Modification Instructions

ADC Solo
Type: 5155

Exchange of Display Cover

Installation Instructions for Software SOL_1302

Figure 2

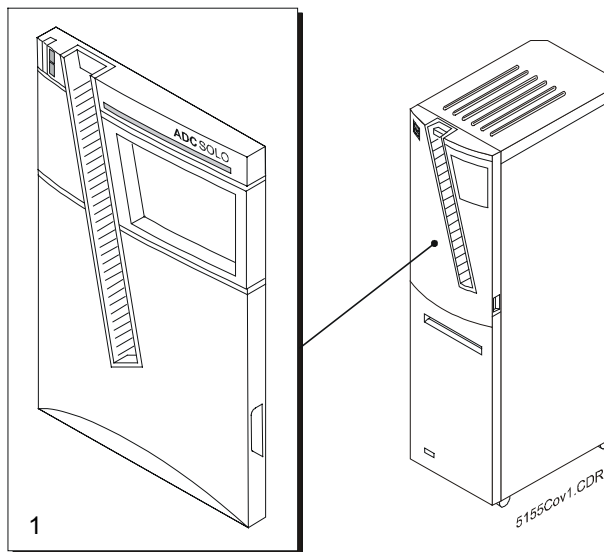
Alternative 1

If no display covers are on stock or if the locking mechanism is broken: Exchange the entire front panel (CM+ 9.5155.1210.2).

1. Remove the right side panel (without tools).
2. Turn the screws of the left panel (quarter turn).
3. Remove the left side panel.
4. Open and remove phillips screws of top panel at rear of the digitizer.
5. Lift top panel and slide it towards the rear.
6. Open the three phillips screws along the left side and the three phillips screws along the right side of the front cover. Be careful with the washers.

7. Open the front door at the bottom of the digitizer.
8. Remove the front panel to be exchanged.
9. Insert the new front panel in reverse order of the described steps.
10. When you insert the new front panel make sure that the bores are in the right position.

Figure 3

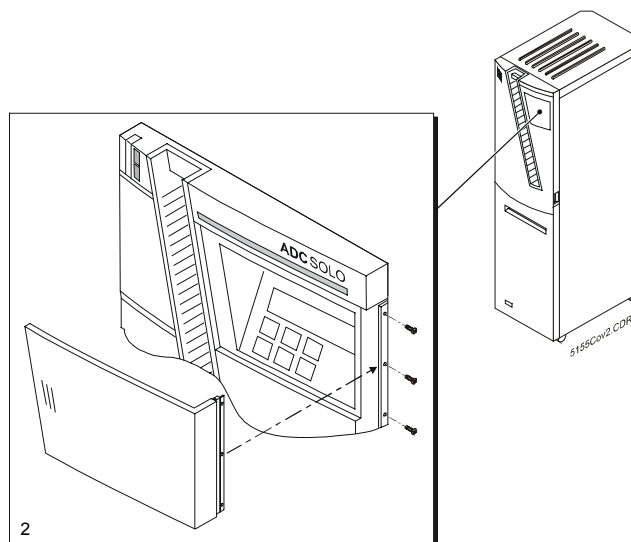
Alternative 2

If display covers are on stock and the hinge of the display cover is broken: Exchange the complete display cover including the hinge (CM+9.5155.9060.1).

1. Remove right side panel.
2. Remove the three phillips screws of the plastic hinge. Use a phillips screw driver.
3. Pull the old hinge out of the frame.
4. Insert the new hinge into the frame.
5. Fix it with the phillips screws.

Figure 4

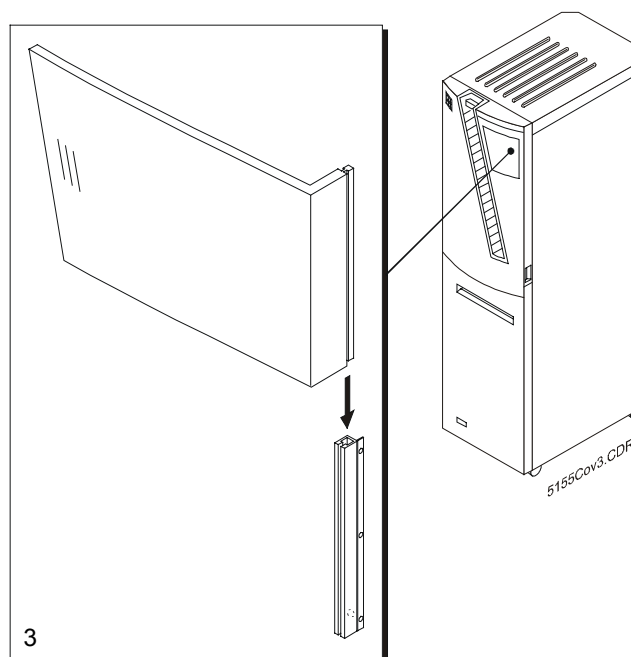
Alternative 3

If display covers are on stock and the hinge of the display cover is not broken: Exchange the display cover only (CM+ 9.5155.9060.1).

1. Open the display cover.
2. Hit it gently but determined either from top or bottom and remove the old display cover by sliding it out of the hinge.
3. Insert the new display cover by sliding it into the rail of the hinge. Slide it until it exactly reaches the level of the hinge.
